<i>MaSPR-24-01</i>	<i>Staff Report – February 12, 2024</i>
<i>Application Type:</i>	Major Site Plan Review
<i>Project Address:</i>	210 Hamilton Street (111.-11-03.0)
<i>Summary of Proposed Action:</i>	Demolish existing structures to redevelop site into a Starbucks beverage café drive-thru and drop-off window with no indoor seating.
<i>Owner/Applicant</i>	Stephen Case, 315 Development, LLC (Owner) Joseph M. Cavender, QPK Design (Applicant)
<i>Existing Zone District:</i>	Mixed-Use Transition, MX-3 Zone District
<i>Surrounding Zone Districts:</i>	The neighboring properties to the north, south, and west are MX-3 Zone Districts, and to the south is the R5 High density Residential Zone District.
<i>Companion Application(s)</i>	Encroachment application, area variance application, road cut permit application
<i>Scope of Work:</i>	The proposed scope of work includes demolishing existing structures and redeveloping the existing site for a drive-through and pick-up only coffee shop with no dining facilities. Vehicular entry to the site will be obtained with a proposed curb cut on North Lowell Avenue for access to the parking lot and drive-through. The drive-through exits back to North Lowell

A1 FIRE ACCESS PLAN
1" = 20'

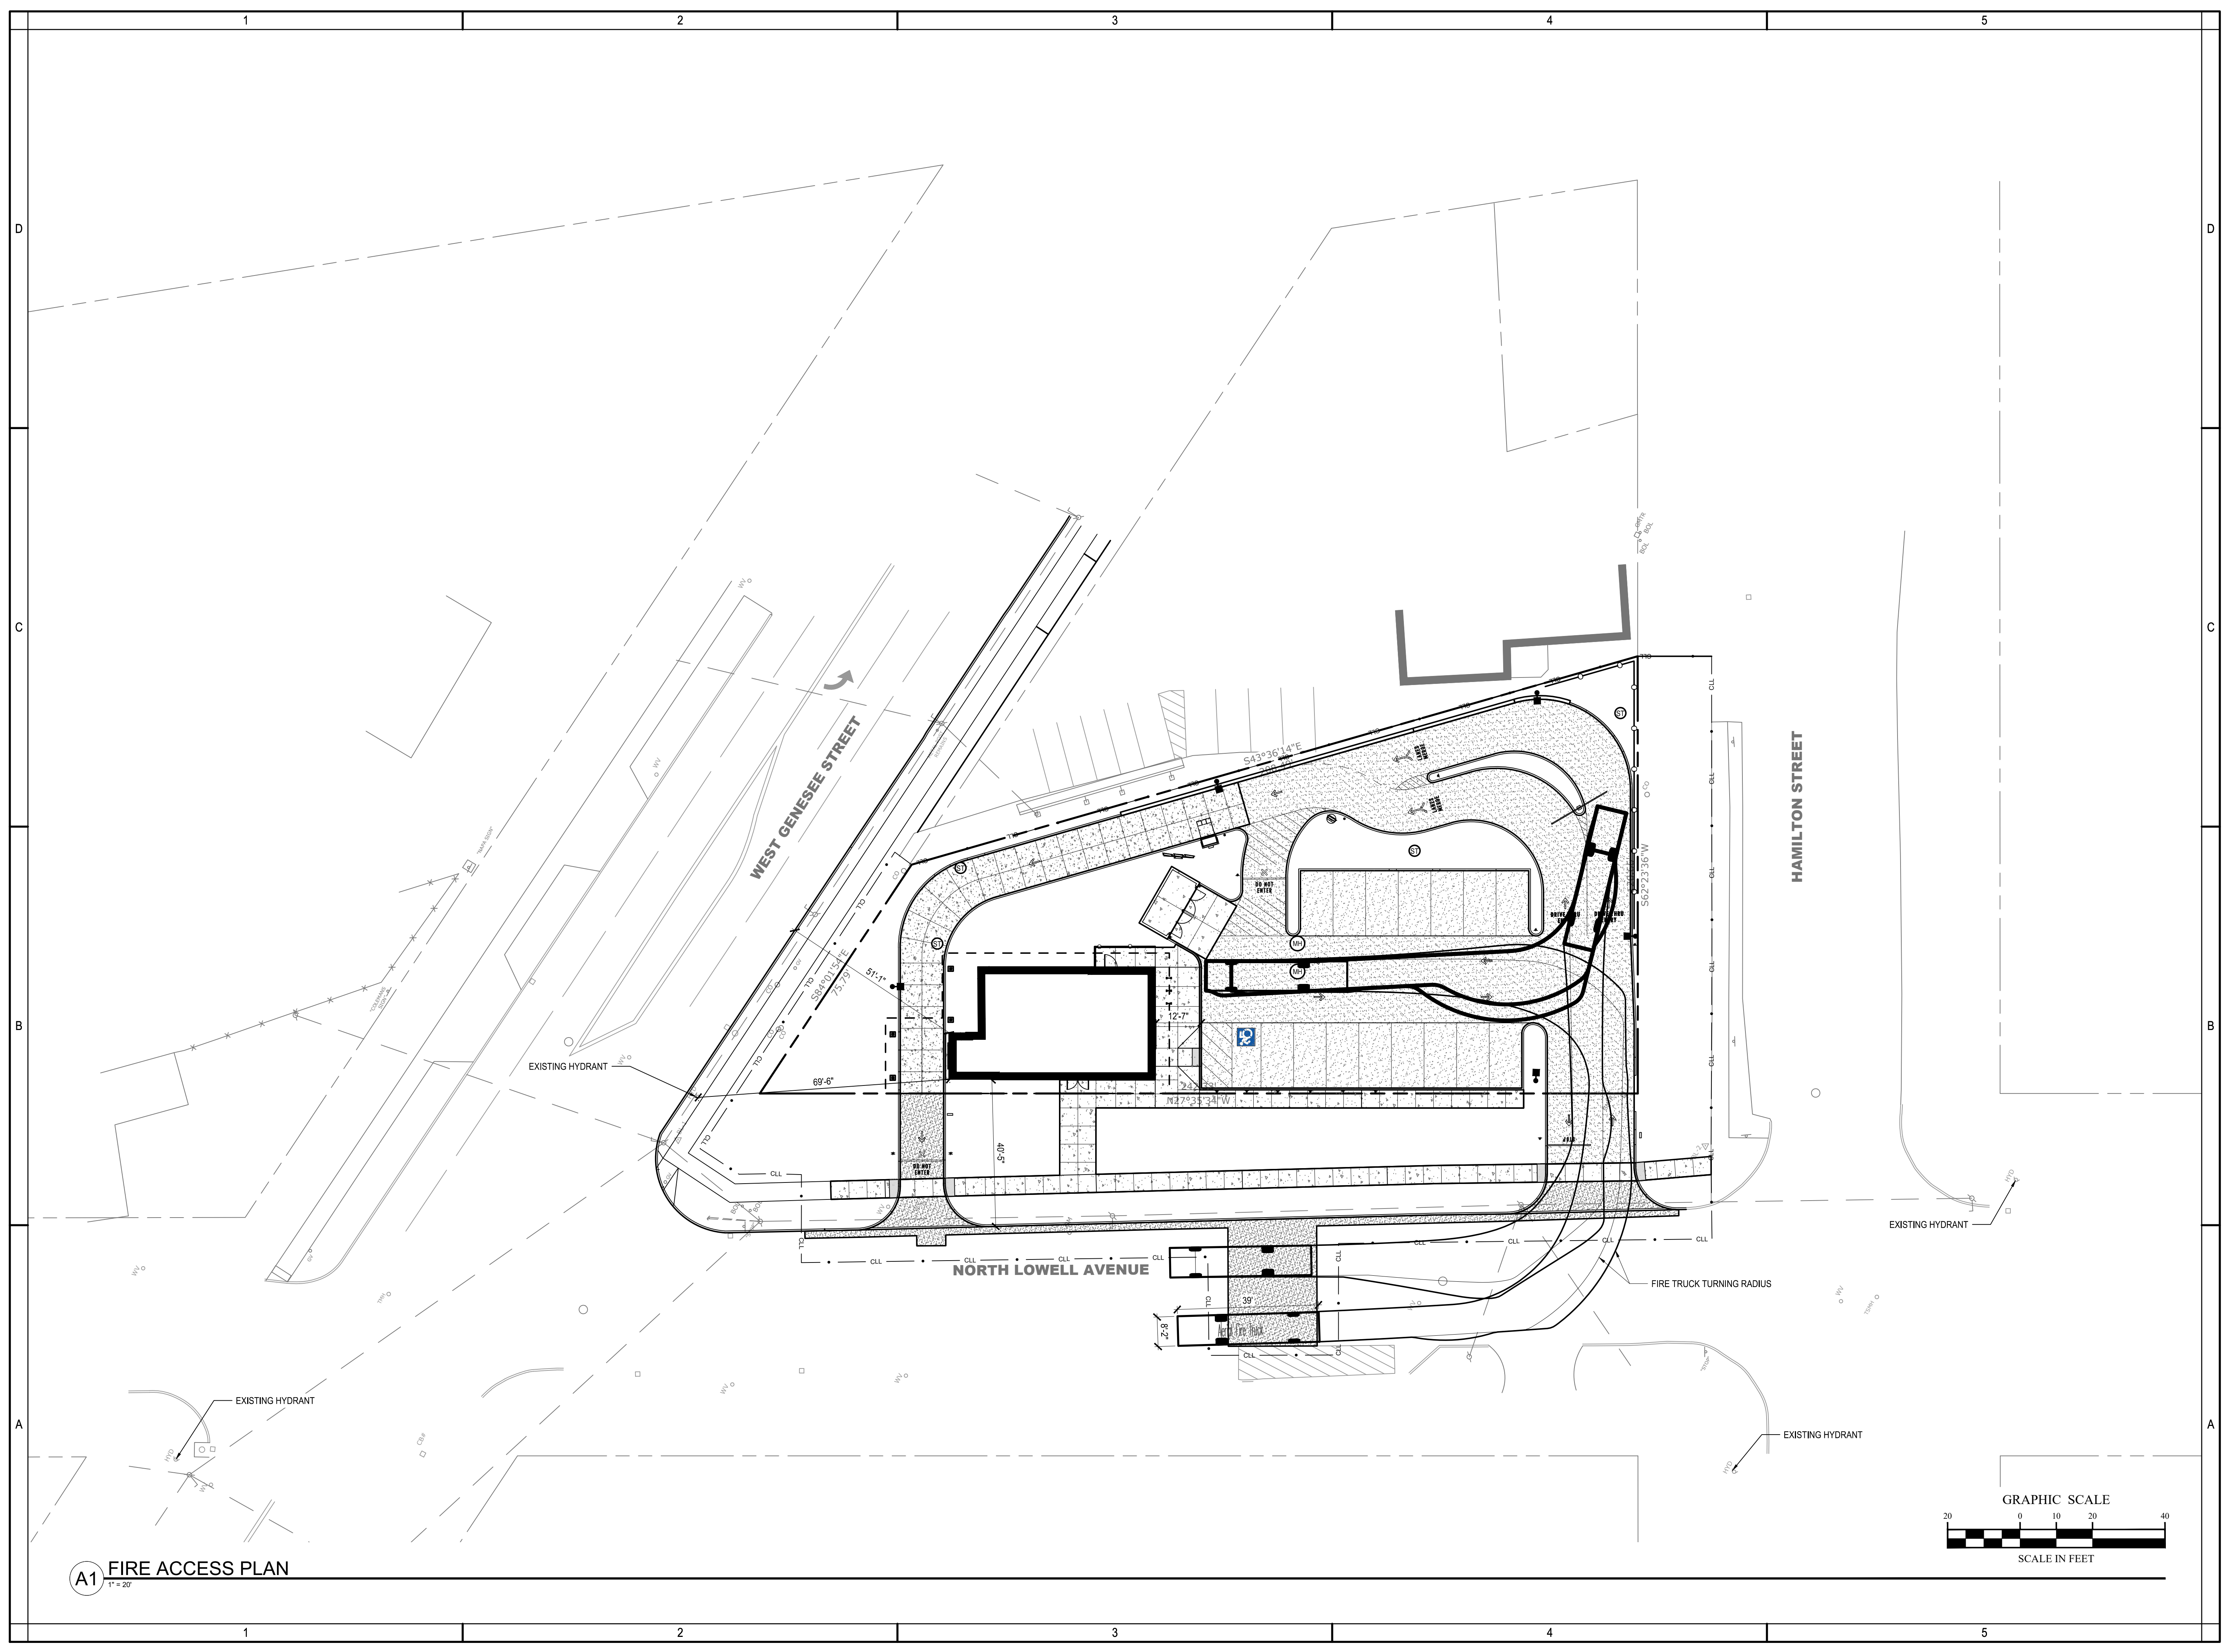
Fire Prevention Bureau	Conditionally Approved	01/09/2024	Elton Davis	<p>1. A fire access plan sheet shall be submitted clearly documenting:</p> <p>a. The locations and dimensions of all required fire apparatus access roadways (Fire Code of New York State §503) and all required aerial fire apparatus access roadways (FCNYS §D105). Widths and distances from the access roadway to all portions of exterior walls shall be documented.</p> <p>b. Locations of all fire hydrants. Distances from each building to the nearest hydrant shall be shown (FCNYS §507.5.1). Any buildings that will require standpipe systems shall have a hydrant located within 100 feet of the Fire Department Connection serving the system (FCNYS §507.5.1.1).</p> <p>Construction, alteration, or demolition, including underground buildings shall adhere to applicable sections of Chapter 33 of the 2020 FCNYS. Items not specifically addressed in Chapter 33 shall comply with NFPA 241.</p>

4. Fire Prevention Bureau: A Fire Access Plan has been added, which includes hydrant locations and distance between the building and roads. See sheet L-101.2.

A1 PLANTING PLAN
1" = 20'

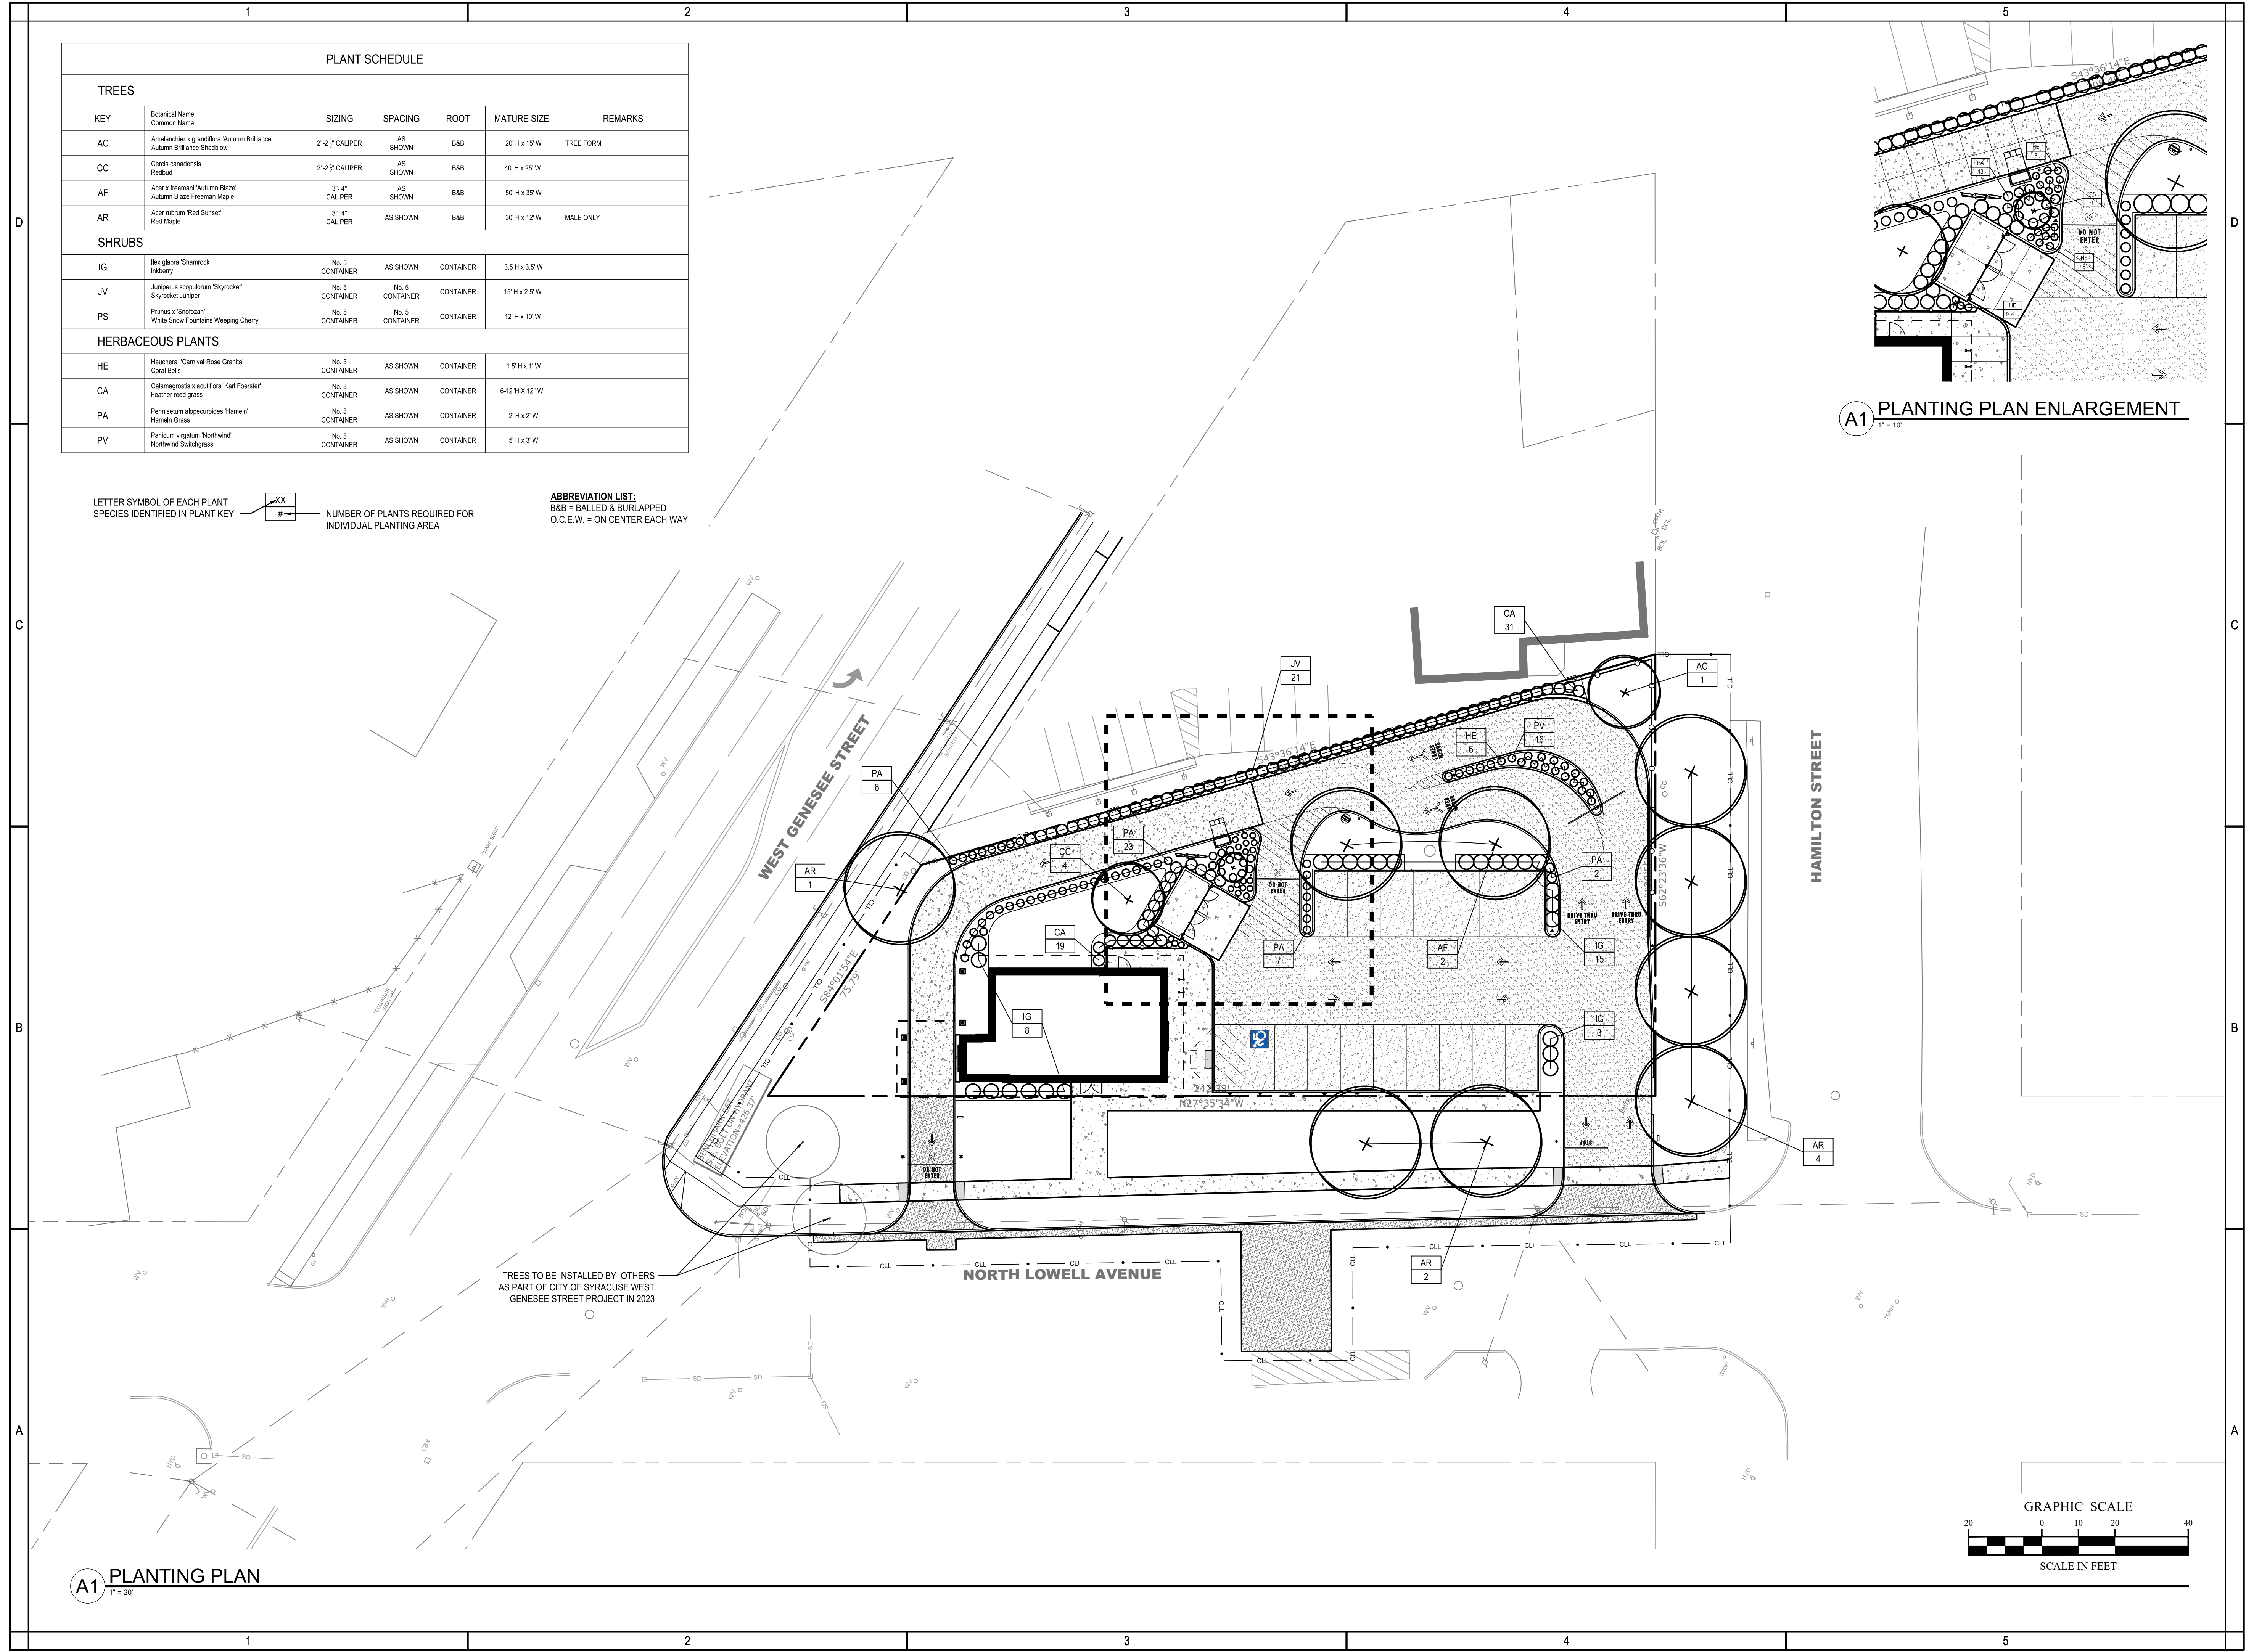
Parks - Forestry	Approved	02/02/2024	Jeff Romano	<p>Forestry requires the following; Swap out the ginkgo trees for a native species, plant in groups of 3. Place additional trees (as shown in graphic) to match the planting plan along W Genesee and N. Lowell Ave (total of 4). The amount of asphalt area of parking seems excessive; is it possible to remove the bay of 7 parking spaces to expand the 'island' and plant additional trees?</p> <p>UPDATED - 2/2/2024</p> <p>Comments on updated Site Plan;</p> <p>Forestry requires to modify the single species planting along W Genesee, Hamilton and N. Lowell. Place tree species in groupings of two or three that complement species characteristics. Swap out Maple species for</p>

other, less used tree species. Feel free to contact City Forestry Division: Jeff Romano for additional information - 315-551-7633. Place additional trees along N. Lowell (currently showing 2 trees)
Revise Plant Schedule to reflect current / updated species selection.
